CITY OF ALBUQUERQUE

Planning Department
Alan Varela, Interim Director

**RE: Western United Electric Supply
Grading and Drainage Plan
Engineer's Stamp Date: 12/27/21
Hydrology File: H10D035**

ENGINEER'S SEAL		DRAWN BY BF
	Western United Electrical Supply Albuquerque, NM		DATE 12/27/2021
	GRADING & DRAINAGE PLAN		2021121_GR
	 5571 MIDWAY PARK PLACE NE ALBUQUERQUE, NM 87109 (505) 858-3100 www.tierrawestllc.com		SHEET # C1
RONALD R. BOHANNAN P.E. #7868			JOB # 2021121

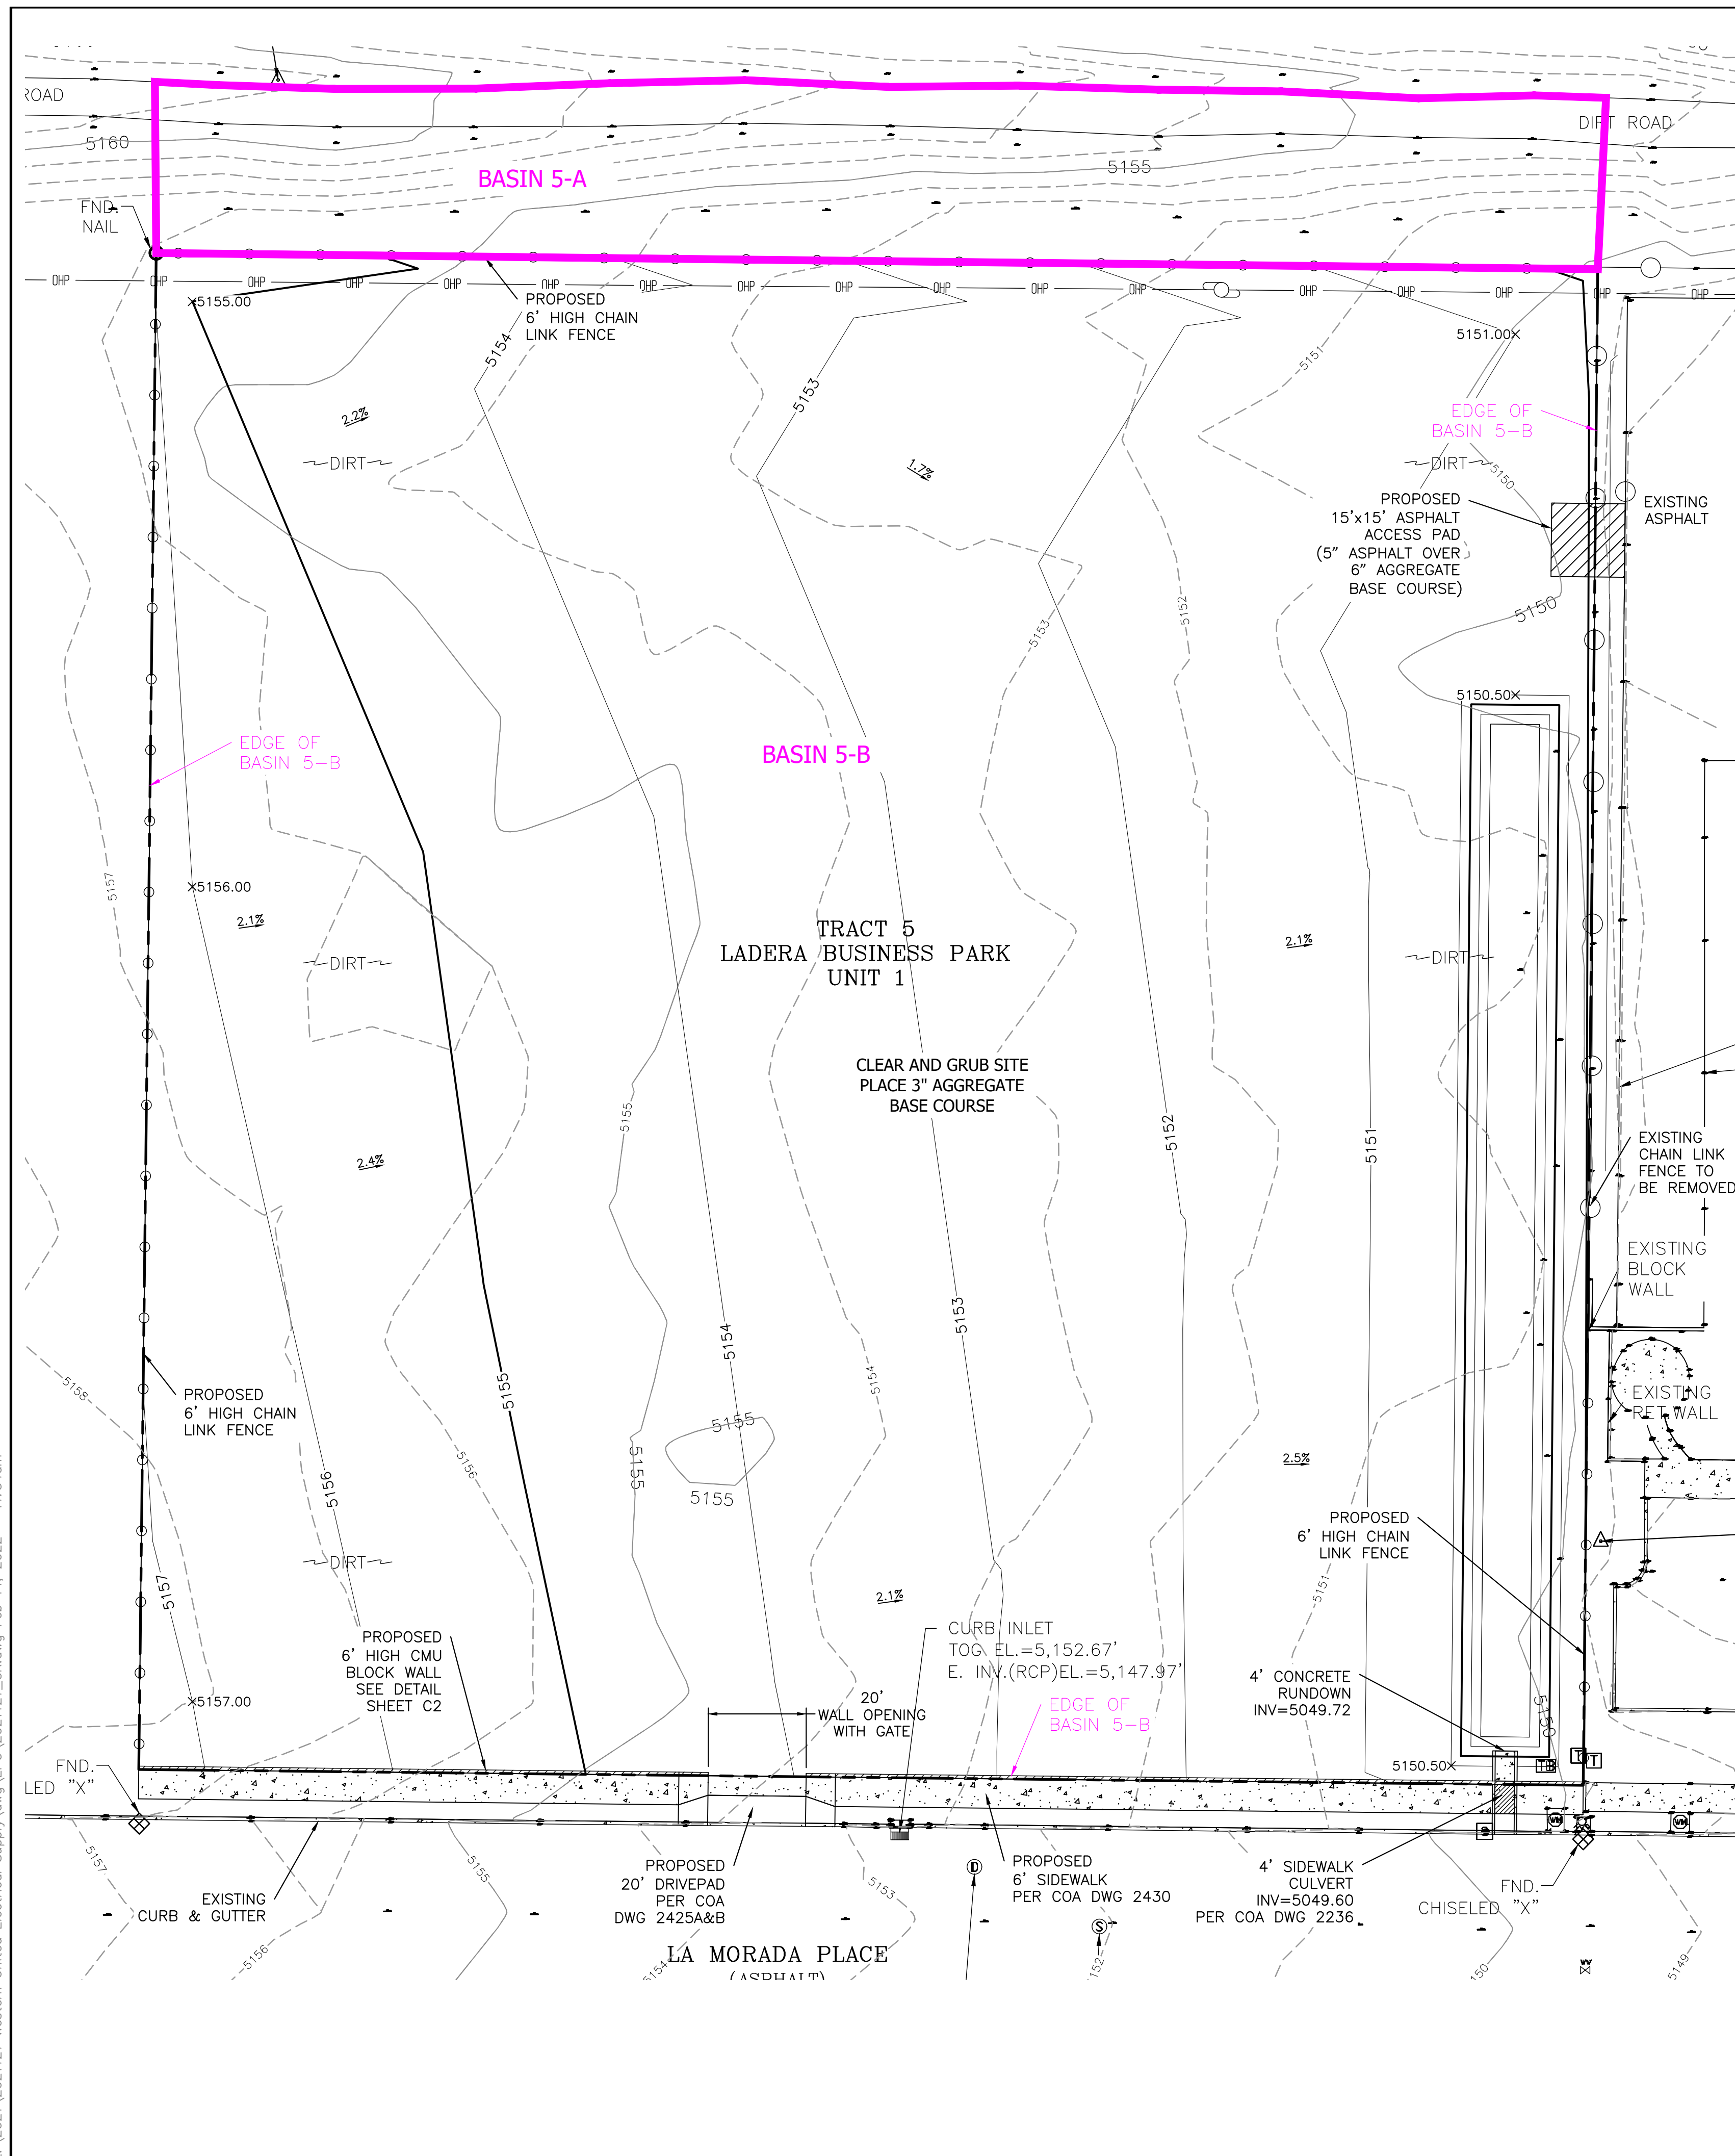
Based upon the information provided in your submittal received 12/27/2021, the Grading & Drainage Plan is approved for Grading Permit and SO-19 Permit. Once the grading of the project is complete, please provide an as-built for Hydrology's records.

Please provide the Drainage Covenant with Exhibit A for the stormwater quality pond per Article 6-15(C) of the DPM prior to Permanent Release of Occupancy. Please submit the original copies along with the \$ 25.00 recording fee check made payable to Bernalillo County to Marion G. Velasquez (mgvelasquez@cabq.gov) on the 4th floor of Plaza de Sol.
